PLANNING COMMISSION  
AGENDA

**NORTHVILLE DOWNS - 301 S. CENTER – HUNTER PASTEUR**
8. **DISCUSSION**

CITY OF NORTHVILLE  
Planning Commission Meeting Minutes  
December 4, 2018  
Northville City Hall  
215 W Main Street, Northville MI 48167  
Council Chambers

# PUD ELIGIBILITY SITE PLAN

**FIGURE 4**  
**BACKGROUND TRAFFIC VOLUMES**  
 NORTHVILLE DOWNS TIS - NORTHVILLE, MI

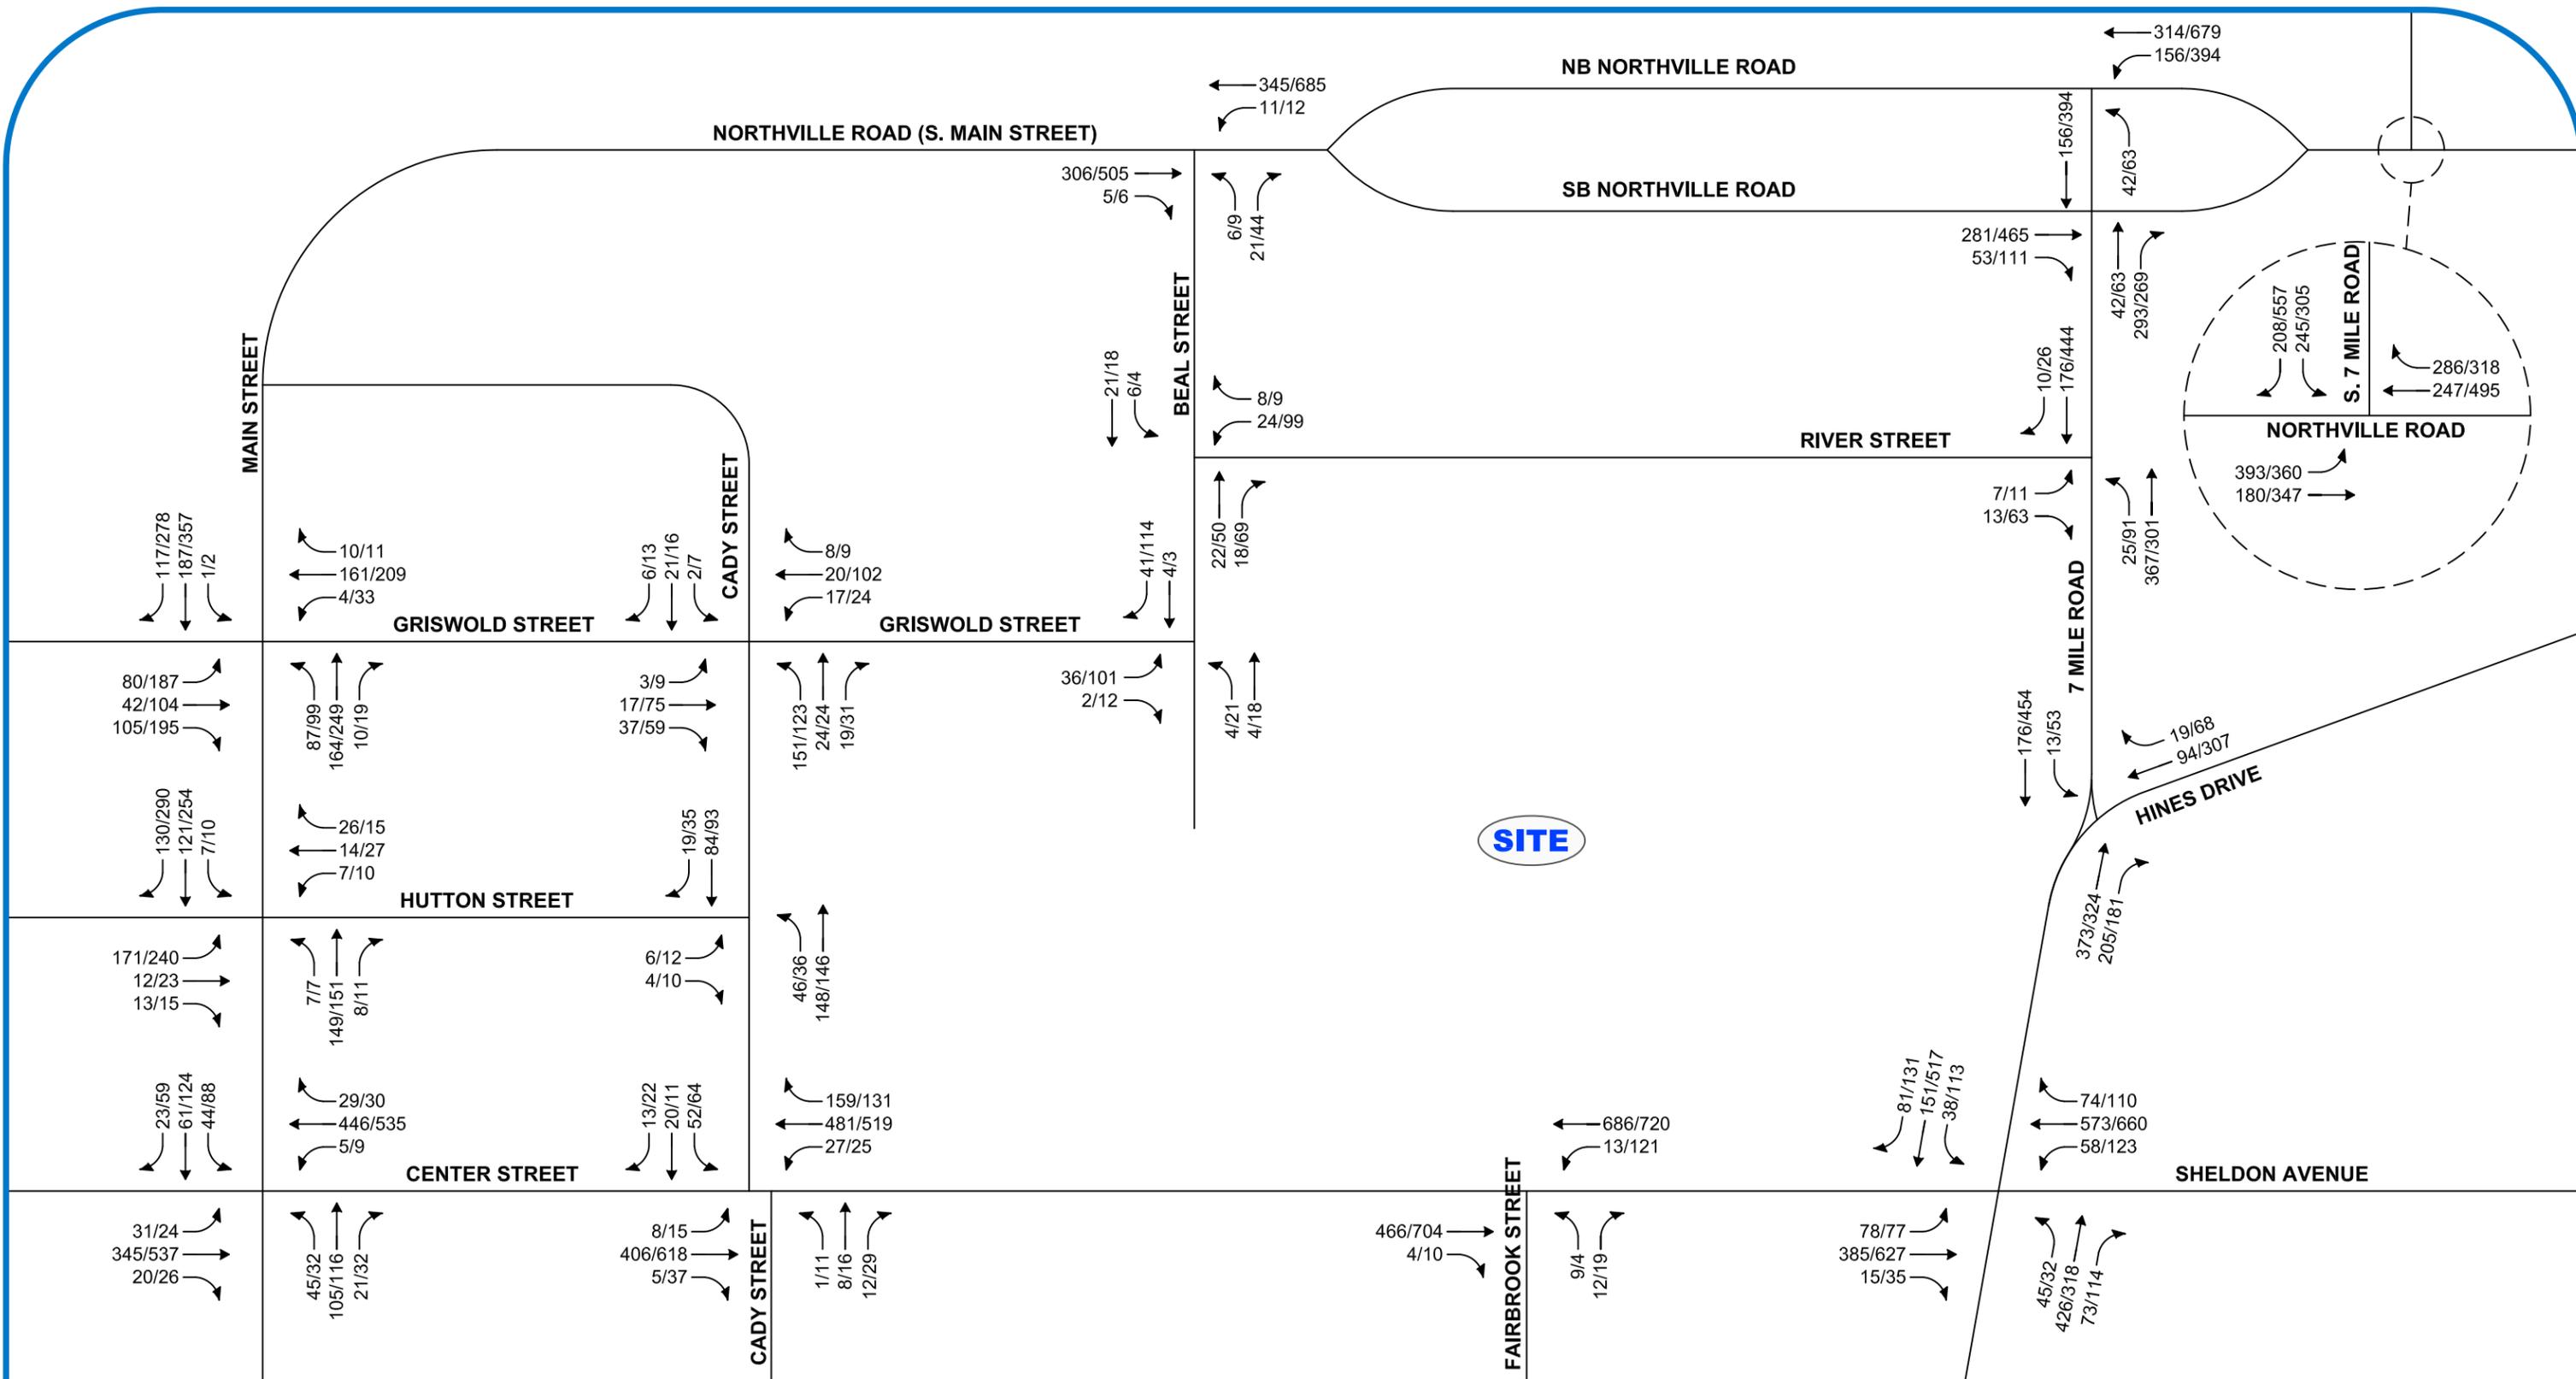
3. Figure 4 shows intersection control symbols in the legend, however these symbols are not shown at any intersection in the main network layout. (Section 3.4: Background Operations)
